Z-31
(2016)

PETITION NO: Z-31

ZONING COMMENTS:

STAFF RECOMMENDATIONS

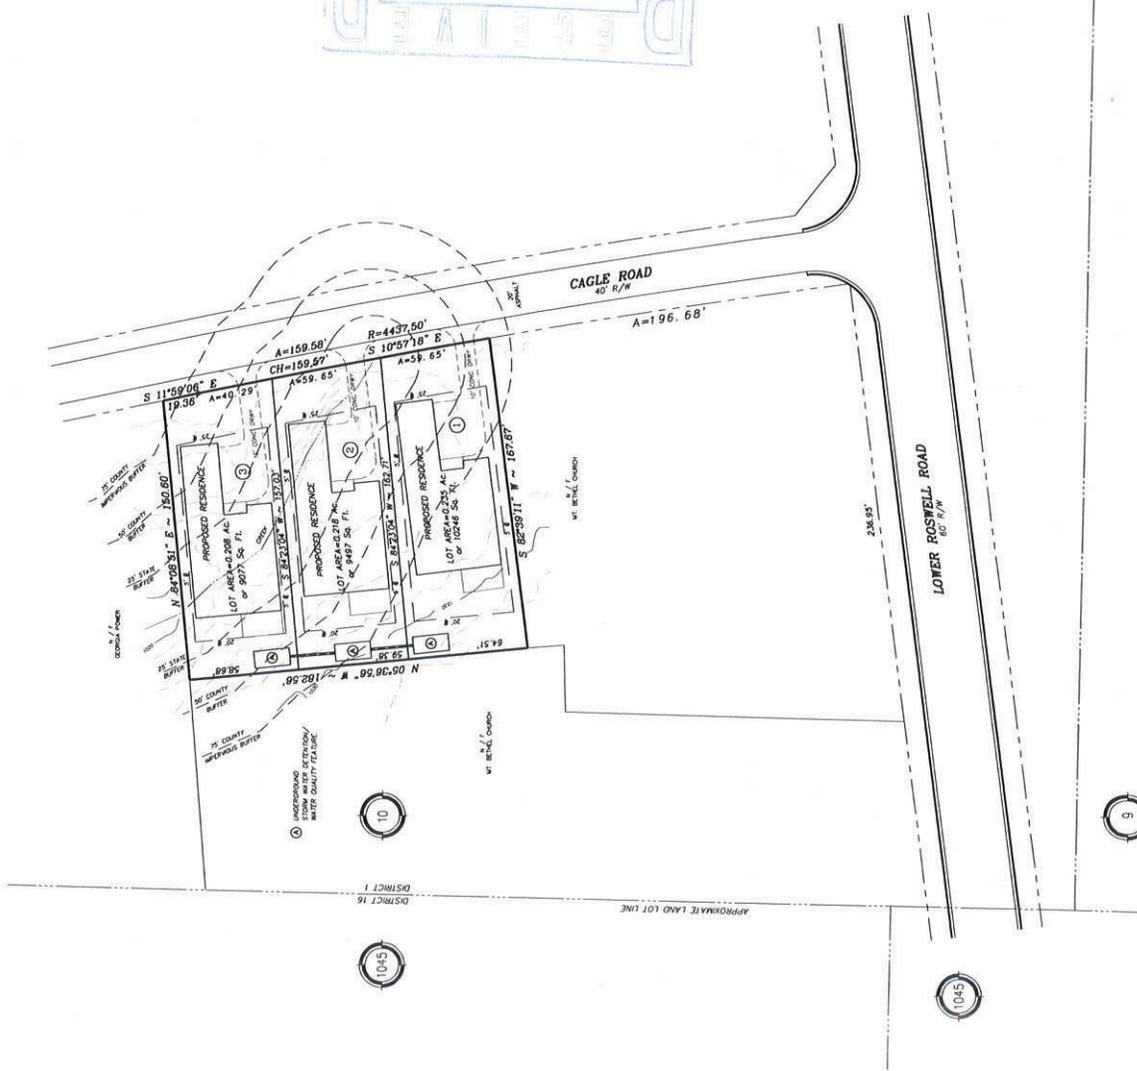
Dead-end access roads in excess of 150 feet shall be provided with a turn-around (IFC 503.2.5 2006 Edition). Cul-de-sac with or without an island: minimum 60-foot radius to outside curb, measured to inside of curb and a minimum lane width = 24 feet (Cobb County Development Standard 401.09). Single-Family cul-de-sac without island: 38-foot outside radius with island reverts to commercial dimensions. Hammerhead turn-around: total of 110 feet needed (45 feet + 20 feet wide roadway + 45 feet).

- No Stormwater controls shown _____
- Copy of survey is not current – Additional comments may be forthcoming when current site conditions are exposed.
- No site improvements showing on exhibit.

1. This site is encumbered by an existing stream channel that conveys over 10 acres of upstream drainage area and has a 50-foot Cobb County and 25-foot State stream buffer associated with it. It is unlikely that the small size of this parcel will allow for three lots while still providing for adequate conveyance of stormwater through the site. In addition, a three lot development requires detention to be provided that will virtually eliminate a significant portion of one of these lots.

Cagle Road is classified as a local and according to the available information the existing right-of-way does not meet the minimum requirements for this classification.

- E. It is Staff's opinion that there are existing and changing conditions affecting the use and development of the property which give supporting grounds for deleting the applicant's rezoning proposal to R-12. The proposal requires numerous variances because it does not meet the requirements of RA-5. While the site plan demonstrates the minimum lot size of 7,000 square feet for RA-5 is being met, the minimum tract size required for RA-5 is 80,000 square (almost two acres) and the property submitted in this application is only 0.662 acres (approximately 28,836 square feet). Properties along this section of Cagle Road are zoned R-20 and have larger lots, but the area has development that is slightly more intense than R-20. Also, as noted in the Department of Transportation comments, the existing right-of-way does not meet the minimum requirements for the local road classification. Staff believes this property does not adequately support the RA-5 zoning district, but a deletion to R-12 would allow two lots with a density of 3.02 units per acre which is in the middle of the density range for the area

Based on the above analysis, Staff recommends **DELETION TO R-12** subject to:

1. Maximum of 2 lots, with District Commissioner approving the final plan;
2. Front and rear setbacks to be reduced to 25 feet each;
3. Fire Department comments and recommendations;
4. Water and Sewer Division comments and recommendations;
5. Stormwater Management Division comments and recommendations;
6. Department of Transportation comments and recommendations; and
7. Owner/developer to enter into a Development Agreement pursuant to O.C.G.A. §36-71-13 for dedication of system improvements to mitigate traffic concerns.
